I note we are meeting next Monday 3.00pm to again review your Draft Final RtS presented at the community meeting on 13 March last. The RtS was poorly received by the community attendees. A number of shortfalls in SM's SSDA and subsequent Responses to Submissions were ventilated. I will only canvas two issues as I understand others will raise other issues.

Re: SM – SSDA

Project Sydney Modern Art Gallery - Acoustic Review

Re: Sydney Modern Art Gallery - Acoustic Review

ARUP Markup Contained Within Report

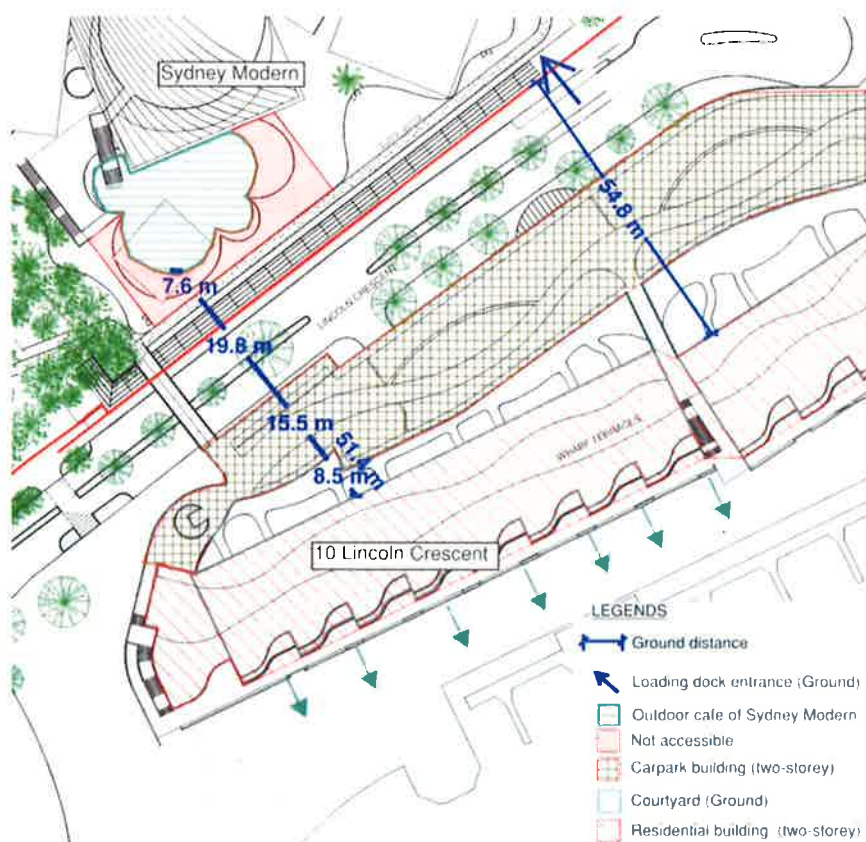
The ARUP Report then calculates the noise impacts to the Wharf Terraces at 10 Lincoln Crescent assuming distance loss and acoustic barrier effects to be $L_{Aeq15min}$ 43 dB.

The ARUP Report states this noise impact at the Wharf Terraces is compliant with the daytime (55dBA) and evening (44dBA) noise criteria of the NSW Industrial Noise Policy (INP) and unlikely to be noticeable.

PKA disputes ARUP's calculated noise impacts and noise criteria.

ARUP does not provide any noise modelling or detail regarding their assumptions of distance loss. PKA's preliminary calculated distance (D) loss of approximately 60m, assuming a best-case of $20\log(D)$, is a 36dBA reduction.

PKA Markup of Site Photo Taken During Inspection

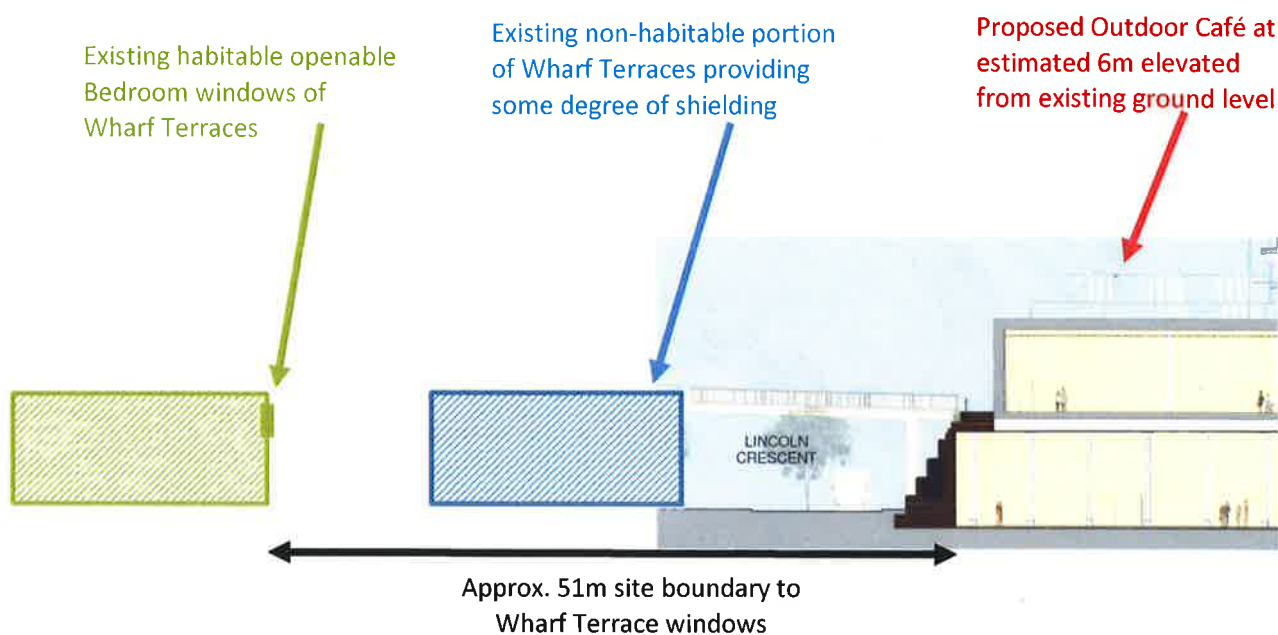
ARUP does not provide any noise modelling or detail regarding their assumptions of acoustic barrier effects. During PKA's inspection of the proposed site and the Wharf Terraces we estimated the existing shielding provided by the non-habitable (western) portion of the Wharf Terraces to be minimally line-of-sight shielding as follows:

To further highlight the location of the Outdoor Café in relation to the Wharf Terraces, the markup below incorporates a portion of an Architectus section drawing with PKA's approximate locations and distances of the Wharf Terrace windows. As PKA has not conducted a detailed noise model, we anticipate at best a 10dBA shielding reduction.

Location of PKA Noise Measurements at Wharf Terraces (facing toward proposed site)

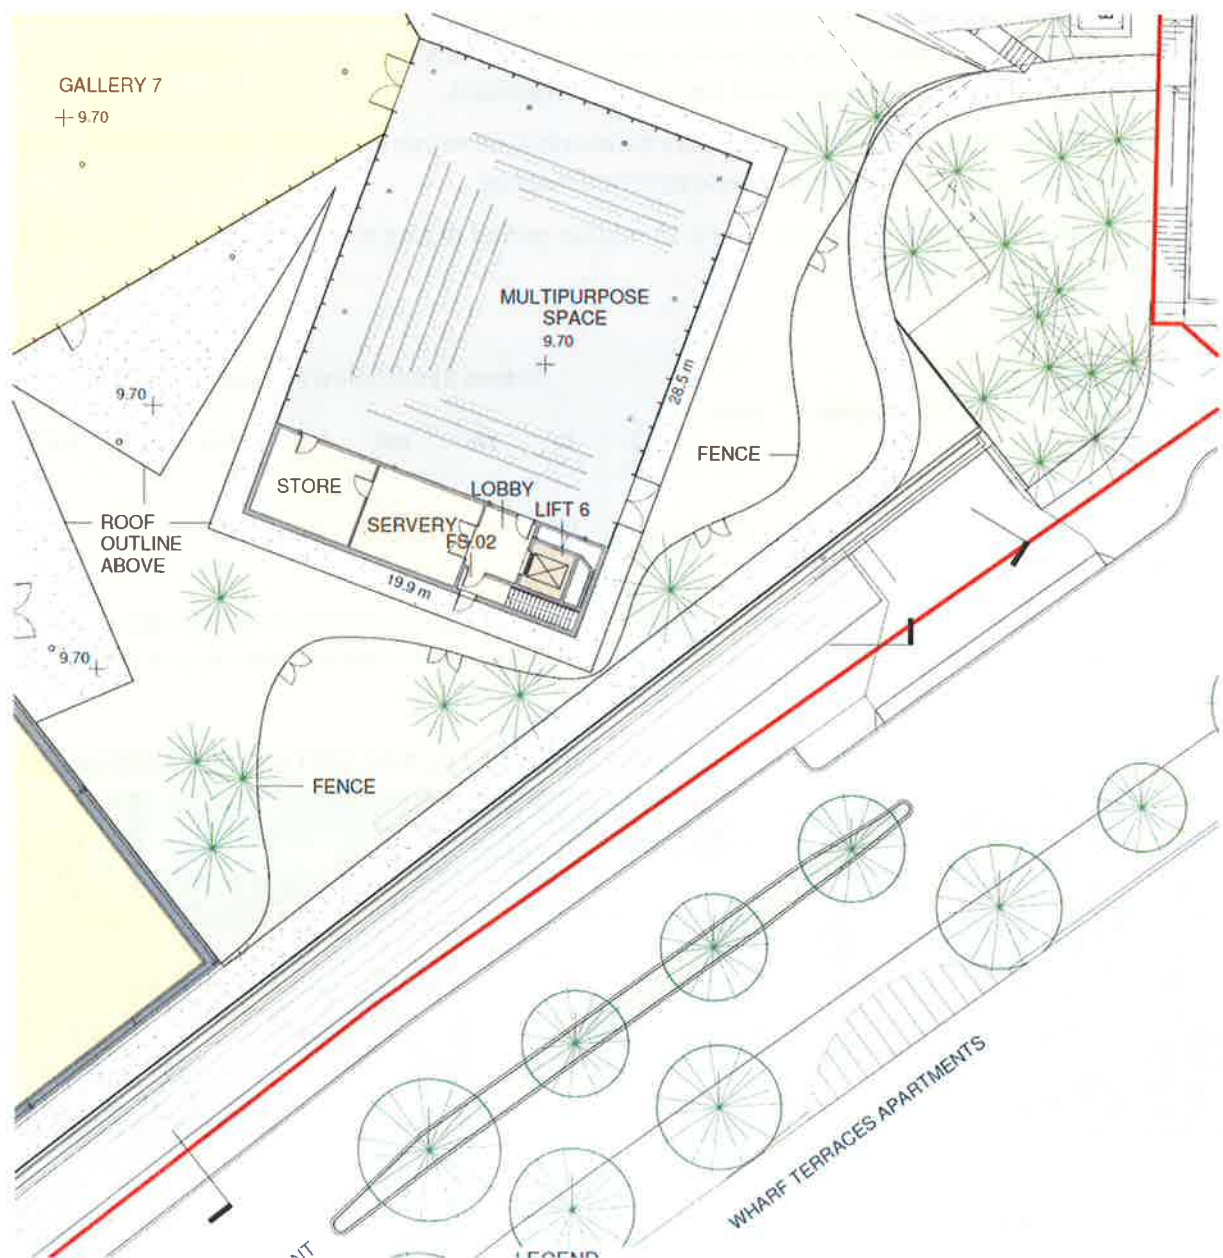
During our site visit we conducted an octave band noise measurement at the Wharf Terrace window location to provide data for a future assessment if needed.

The noise measurement was taken over a 15 minute period during the daytime from 11:15 to 11:30 on the 9th May 2018 as follows:

Entry walkway of #25 and #26 Wharf Terraces	Descriptor	dBA	Octave Band Centre Frequency (Hz) dBZ								
			31.5	63	125	250	500	1,000	2,000	4,000	8,000
Noise dominated by distant traffic from Cahill Expressway	L_{90} (Background)	45	58	59	52	47	41	40	35	22	20

PKA requests that ARUP clarifies whether the Outdoor Café and/or associated areas will be licenced. If so, PKA recommends that a detailed acoustic assessment of the Outdoor Café noise impacts be undertaken to inform whether additional acoustic treatment and/or operation limitations are required.

PKA Markup of Site Photo showing Proposed Plantroom Location

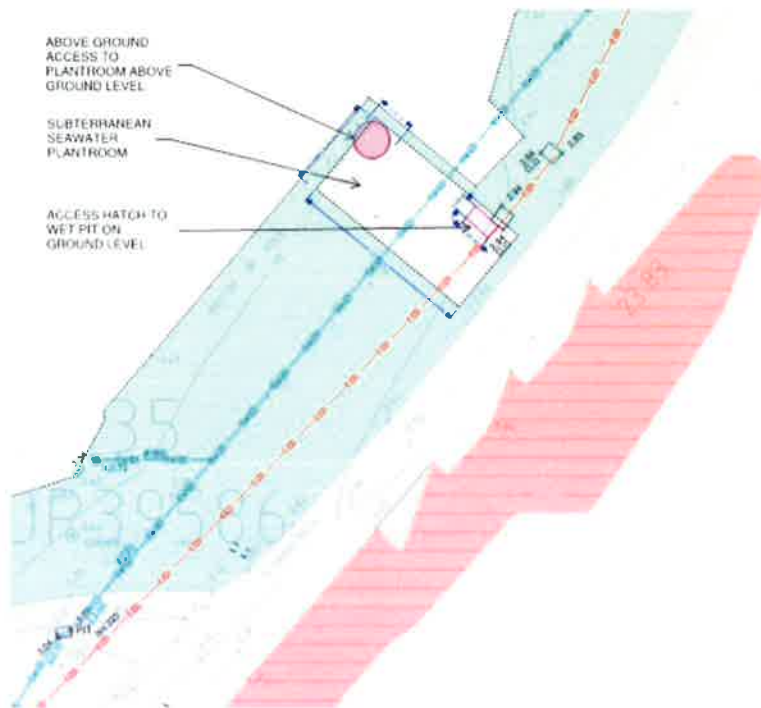
The ARUP Report, in Section 5.2.2, conducted an acoustic assessment into the Seawater Heat Exchange Cooling System.

The proposed plantroom is in close proximity to the Wharf Apartments, specifically our client located on Level 1, Apartment 34 with openable windows facing the proposed location.

Steensen Varming in Proposed Markup Appendix H (Job: 14702 can020, 2018-03-16)

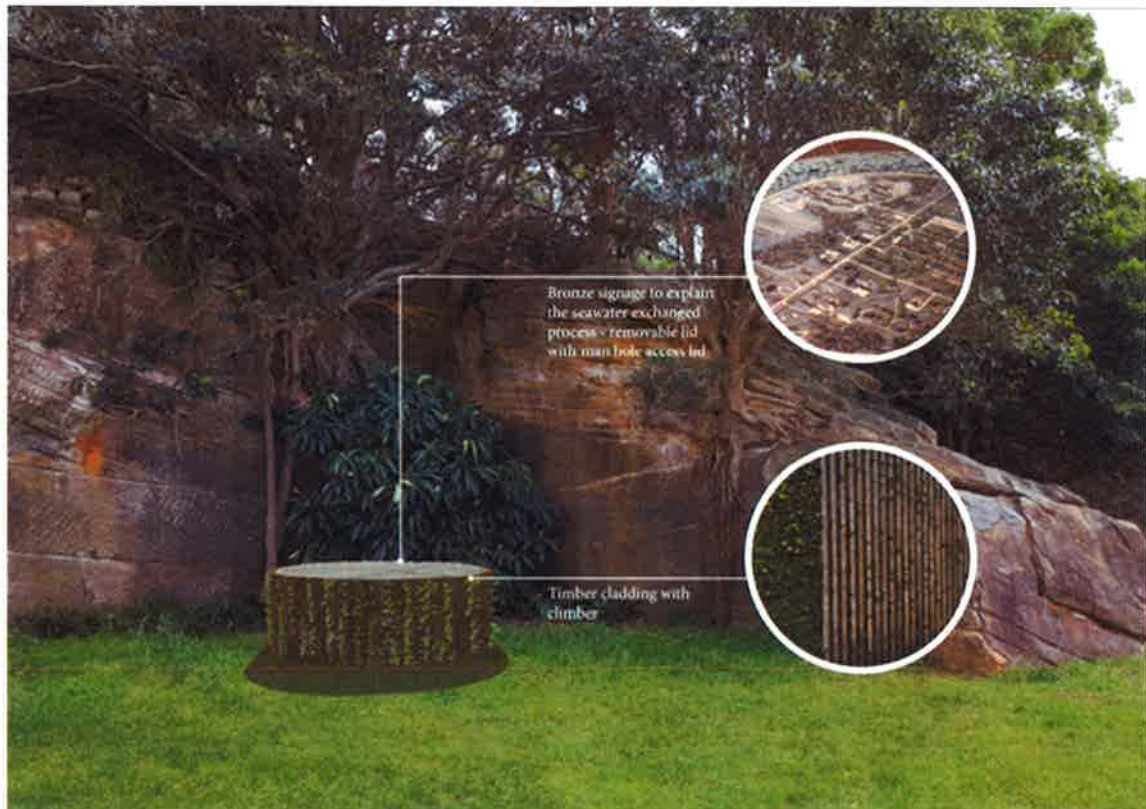
The ARUP Report states that plant selections are not currently known, which PKA accepts due to the SEARS stage of the project. However, ARUP goes onto predict the noise level based on the preliminary design and equipment selections.

The ARUP Report does not state the source noise levels assumed in the calculations, making it difficult for PKA to determine whether ARUP's predicted noise level of L_{Aeq} 29dB showing compliance is feasible.
